**NOTICE OF ADDENDUM
ADDENDUM NO. 1**

**CONTRACT NO. 8061, PROJECT NO. 11591
FIRE STATION 10 – STOREFRONT GLASS REPLACEMENT**

CONTRACT NO. 8061
FIRE STATION #10 – Storefront Glass Replacement

3 A Elevation North
1/8" = 1'-0"

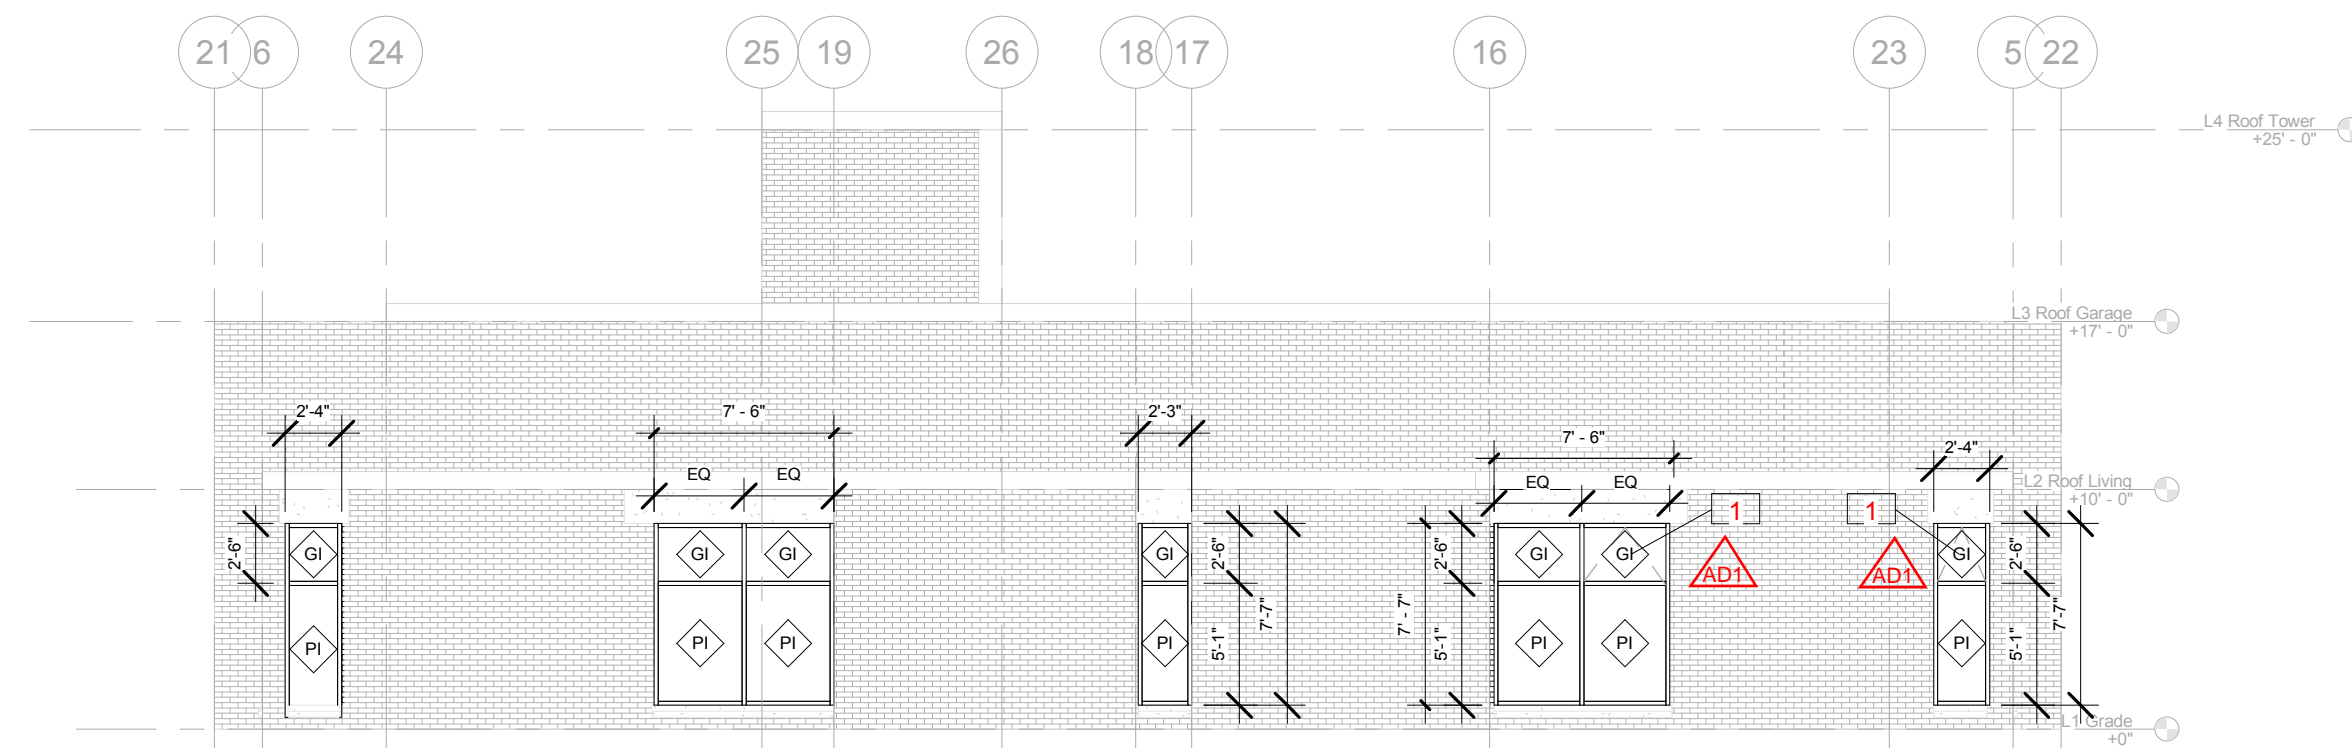
Drawings updated to remove Hazardous Substance section – not part of this project.
Added glass manufacturer provided insect screens

**WINDOW MANUFACTURER
TO PROVIDE INSECT
SCREENS AT ALL
OPERABLE WINDOWS**

Spec. Section 08 41 13 Aluminum-Framed Entrances and Storefront
Part 2.3.E – Install window-manufacturer provided insect screens in all operable windows
